Airspace Change Proposal ACP-2020-064

Summary of Stakeholder Engagement and Final Proposal

Skylift UAV Limited
Version 1.0
19/10/2020

DIAGRAM 1 – Proposed Zone Revision

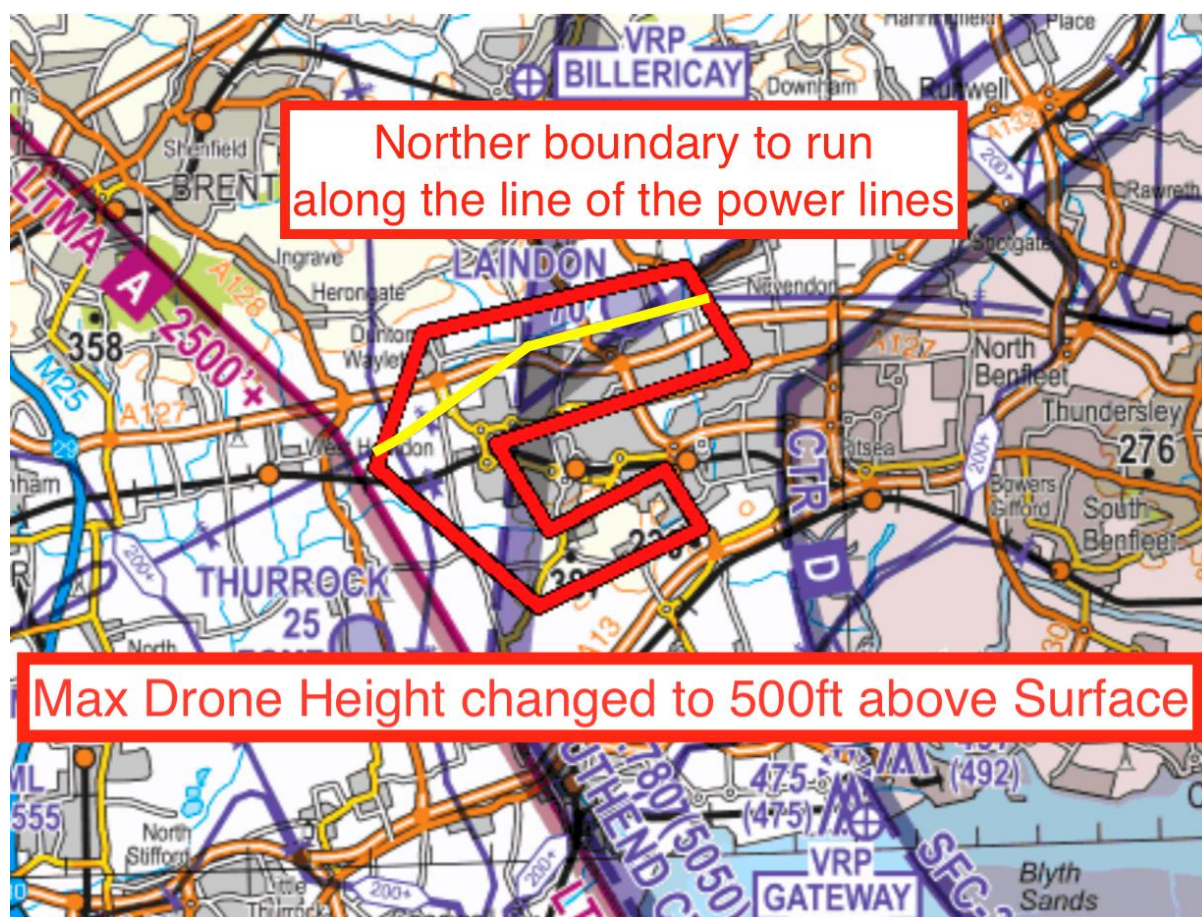
The TDA should be changed as per Diagram 1

- a. The northern limit of the zone to follow the power lines
 - i. **REASON** - this would physically separate drones and Laindon traffic and remove the need for an airborne crossing service.
- b. The zone height limit should be set to 500ft above the Surface as per existing drone flying rules.
 - i. **REASON** - "Skylift UAV Ltd" commercial drones should never be permitted to go over 500ft above surface level on any route as going any higher would intrude into the generally used recreational airspace.

DIAGRAM 2 – Proposed Zone Revision

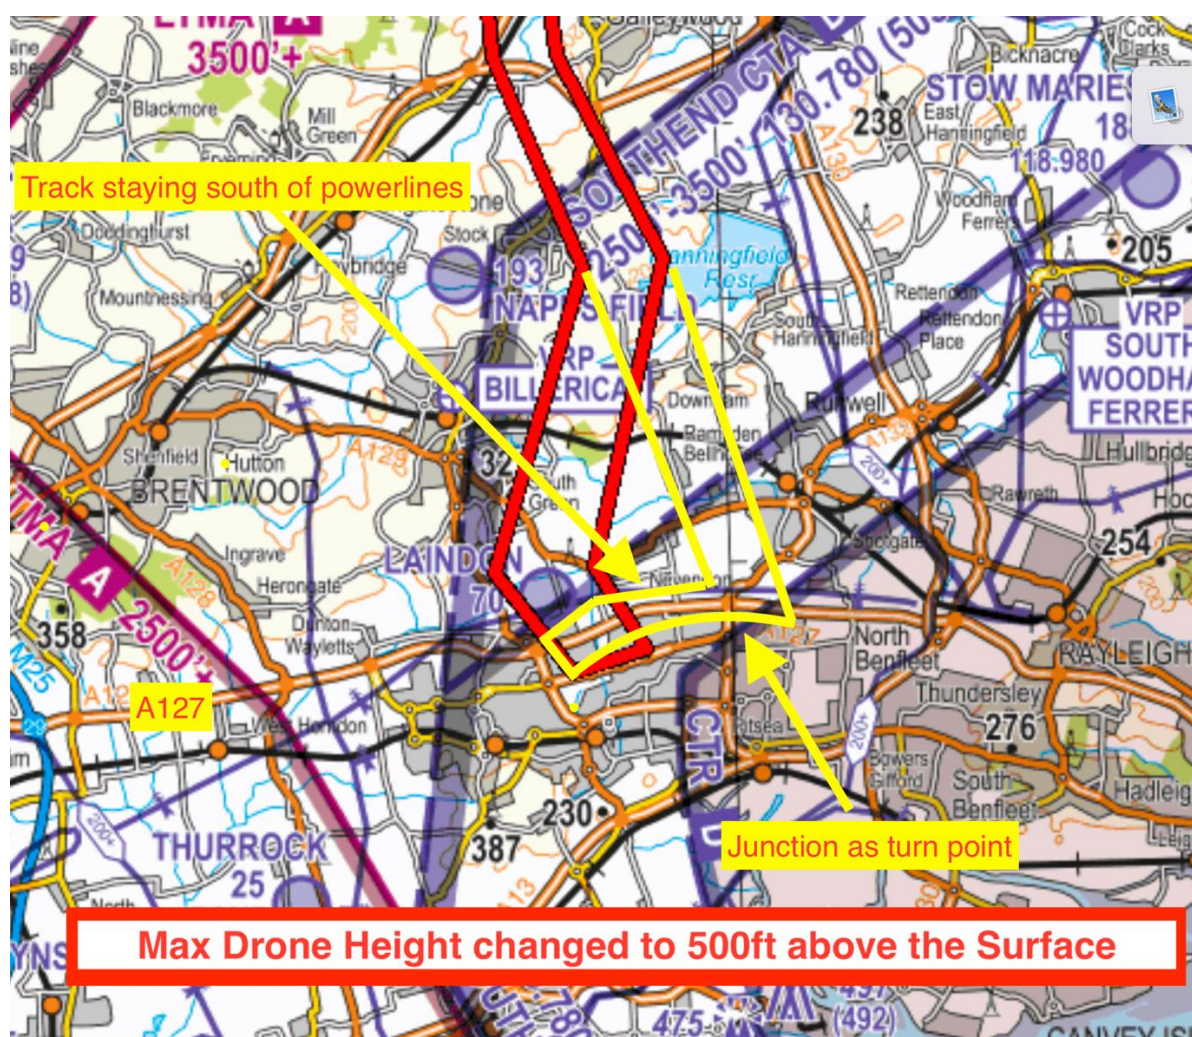
The zone must be changed as per Diagram 2

- a. The zone would follow the power lines 1.5 miles east using the A127 Nevendon road junction as a datum for the zone centre line
 - i. **REASON** - this would keep a separation of Drone and Aircraft
- b. The zone height limit should be set to 500ft above the Surface as per existing drone flying rules.
 - i. **REASON** - "Skylift UAV Ltd" commercial drones should never be permitted to go over 500ft above surface level on any route as going any higher would intrude into the generally used recreational airspace
